Tip 96 — Drawbar and Chuck Adapter Through-Drill Modification/Roger Adams

Modifying the Drawbar and Chuck Adapter

FIGURE 1—The blue box indicates the new drill-through hole for the Sherline Rotary Table-to-Chuck Adapter.

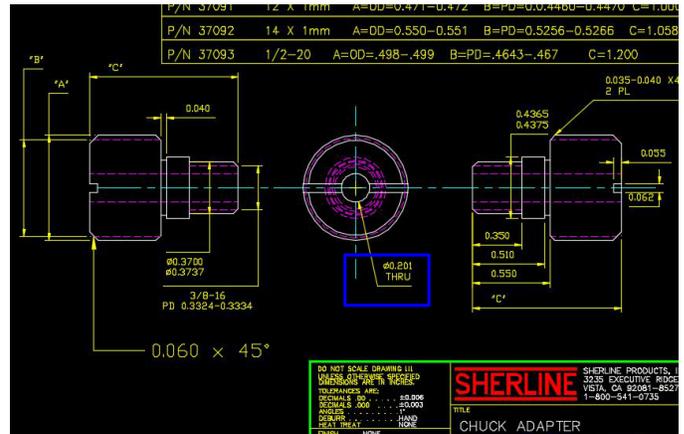
I am using these to make a clock (I'm a clock and watch repairer), and eventually will use them to make a watch from scratch. To this end, I purchased the #3060 milling collets, which I use on both the lathe and the mill for holding and machining drill rod for making clock arbors, etc. If I may make a suggestion regarding these, it would be a good idea if you would supply the associated drawbolt through-drilled to allow a long piece of 3/16", or smaller, stock to be used with them. I actually modified the drawbolt myself like this and it proved most effective. I also through-drilled the #37090 chuck adapter for the rotary table for the same reason. FYI, I needed to mill flats on the end of a long piece of 3/16" drill rod, using the rotary table on the mill to do this and without through-drilling the adapter first as I did, the rod would have stuck out too far from the chuck mounted on the rotary table to allow for this.

With the feedback from Roger Adams, we have decided to add a .201" through-hole to our P/N 37090 Rotary Table-to-Chuck Adapter. This modification will take place on the next part run.
